SUBJECT: Calvert Cliffs Nuclear Power Plant
Unit Nos. 1 & 2; Docket Nos. 50-317 & 50-318
Response to Request for Additional Information Regarding the Use of the
Convolution Technique for Main Steam Line Break Analysis

- REFERENCES:
- (a) Letter from R. E. Denton (BGE) to Document Control Desk (NRC), dated November 1, 1994, Request for Approval to Use Convolution Technique in Main Steam Line Break Analysis
 - (b) Letter from Daniel G. McDonald (NRC) to R. E. Denton (BGE), dated December 1, 1994, Request for Additional Information Regarding the Use of the Convolution Technique for Main Steam Line Break Analysis - Calvert Cliffs Nuclear Power Plant, Unit Nos. 1 and 2 (TAC Nos. M90897 and M90898)

CONVOLUTION QUESTIONS

FIGURE 3-1

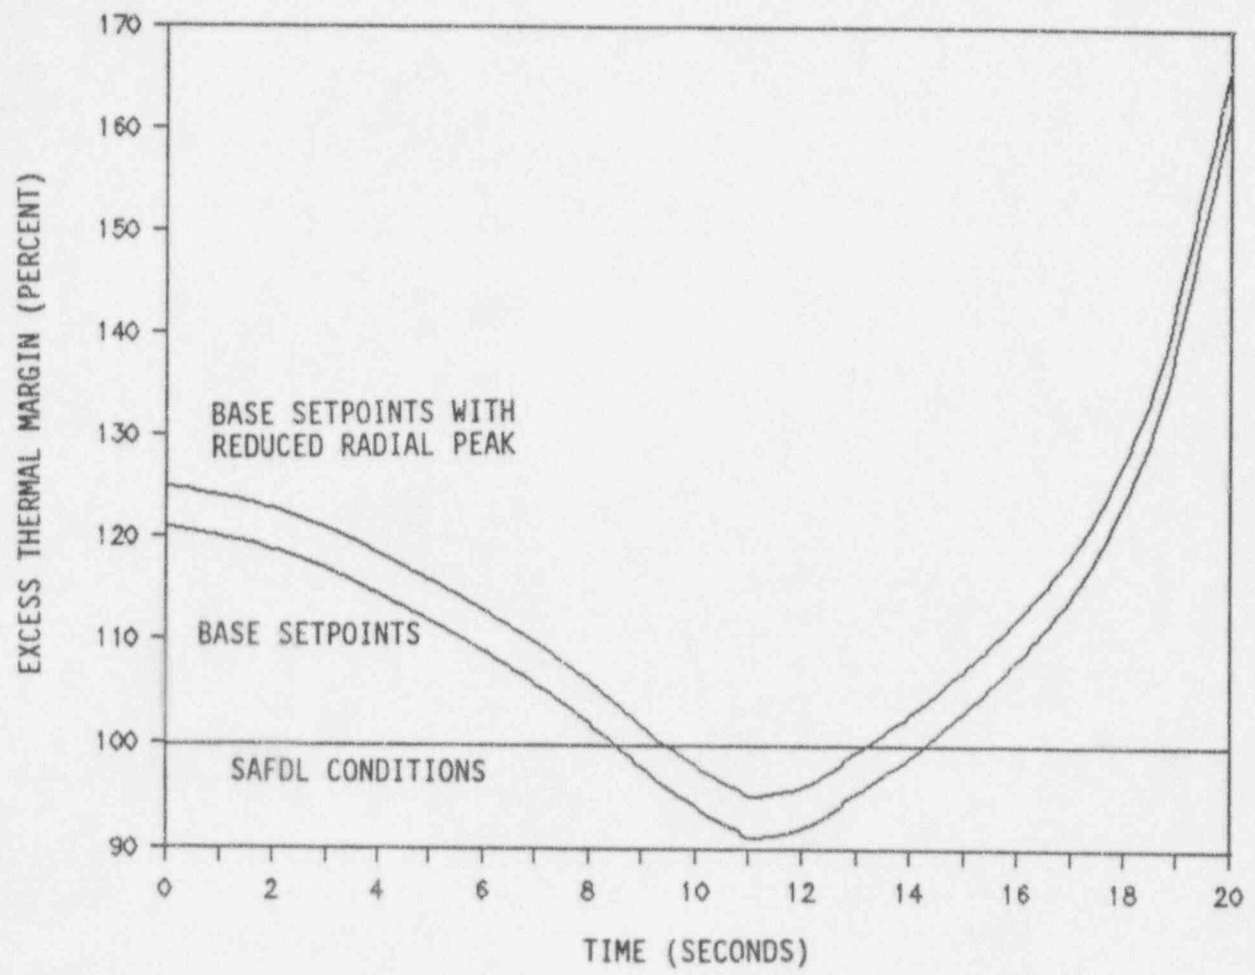
3. Q. What adjustments have been made to the Core Operating Limits Report (COLR) to maintain the MSLB predicted fuel damage fraction to less than 2%?

A. It was possible to maintain fuel failure to less than 2% by restricting the allowed radial peaks in the COLR. The BASSS setpoints and the Departure from Nucleate Boiling Ratio (DNBR) excore Limiting Condition for Operation (LCO) tent for the operating cycles were based upon a radial peaking limit of 1.7. Lowering the radial peaking limit while not adjusting the DNBR LCOs has the effect of preserving the original thermal margin in the accident analysis, thereby limiting the fuel failure fraction.

To provide the additional thermal margin, the COLR radial peaking limits (F_{xy}^T and F_r^T) have been lowered from 1.70 to 1.66 for Unit 1 Cycle 12 and 1.635 for Unit 2 Cycle 10.

The affect of the COLR changes on the Pre-Trip MSLB event may be seen in Figures 3-1 in units of thermal margin to the Specified Acceptable Fuel Design Limits (SAFDL) and in Figure 3-2 in units of DNBR. At time 0 in the "Base Setpoints" case (without the COLR change), the margin between the most limiting pin in the core and the SAFDL is determined by the Required Overpower Margin. The Pre-Trip MSLB event steadily erodes this initial margin until the SAFDL is reached at about 8.5 seconds. The thermal margin continues to degrade, now in violation of the SAFDL, until the point of minimum DNBR occurs at about 11 seconds. The thermal margin then begins to improve as the heat flux decreases following a reactor trip.

The COLR change sets the radial peaking limit to less than the value used to determine the Required Overpower Margin. This has the effect of creating additional margin between the DNBR LCO and the actual core condition. The upper line in Figure 3-1, labeled "Base Setpoints with Reduced Radial Peak," illustrates the minimum thermal margin in the core with the lower radial peaking limit, while the lower line is the thermal margin at which the monitoring system assumes the peak pin is operating. It is seen that the peak pin is actually several percent of thermal margin further from the SAFDL than the conditions assumed by the monitoring system.

The amount of fuel predicted to fail (fuel damage fraction) is dependent upon the extent of violation of the SAFDL of the peak pin (and of the other pins in relation to the peak pin). It is seen that with the lowered radial peak, the extent of the SAFDL violation is reduced.

FIGURE 4-1
SLB RESPONSE TO BREAK SIZE "A"

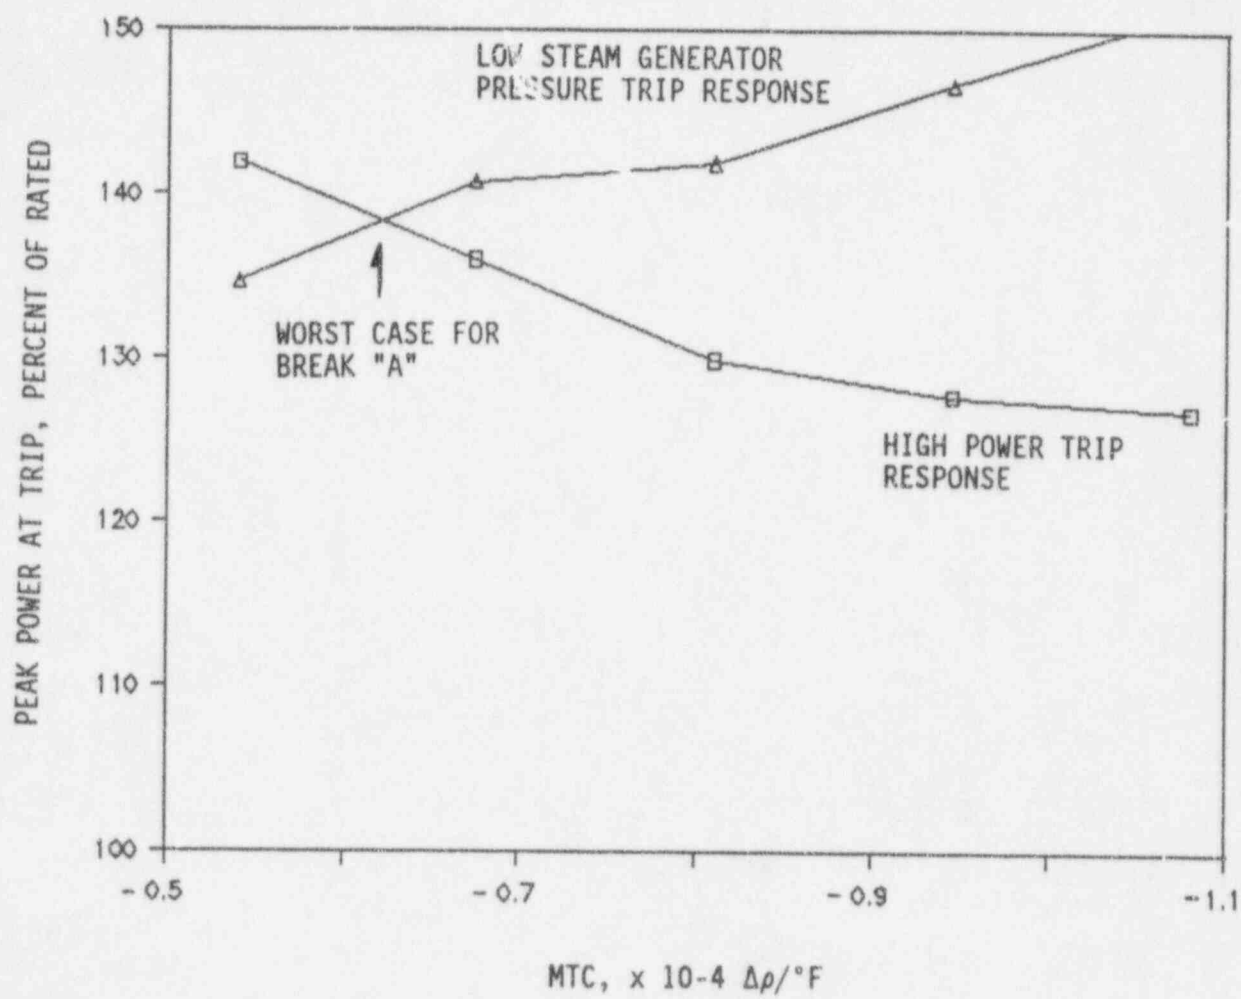
4. Q. Why is the Low Steam Generator Pressure (LSGP) trip setpoint reached so much sooner in the new MSLB analysis (15.3 sec., Updated Final Safety Analysis Report [UFSAR] Revision 17) than in the previous analysis (33.9 sec., UFSAR, Revision 16)?
- A. The worst case for a Pre-Trip MSLB is found by the consideration of many competing dynamic effects, including the relative timing of the Low Steam Generator Pressure trip and the Power Level - High trip.

An analysis is performed which examines the effect of varying the break sizes and MTC values. Figures 4-1 and 4-2 illustrate a representative Pre-Trip MSLB response to two different break sizes, "A" and "B." For each break size, a more negative MTC results in an improved response of the Power Level - High trip seen as a lower peak power. The LSGP trip, however, occurs at higher and higher power levels because the time to depressurize the steam generator and initiate a LSGP trip is nearly constant for a given break size but the peak power increases as the MTC is more negative. Therefore, for a given break size, the limiting condition is the highest of these peak powers that occur before the action of the first of the competing Reactor Protective System trips. The limiting case for the transient as a whole is found by taking the worst predicted response for each of the individual break sizes.

As illustrated in Figures 4-1 and 4-2, the limiting power at time of trip varies only slightly for various worst case combinations of break size and MTC. Since the intersection of the worst case combinations for break size and MTC occurs in a region of the curves that is relatively flat, cycle-by-cycle differences in core parameters can significantly change the limiting break size/MTC point (although these differences have only a minor effect on the limiting power at time of trip).
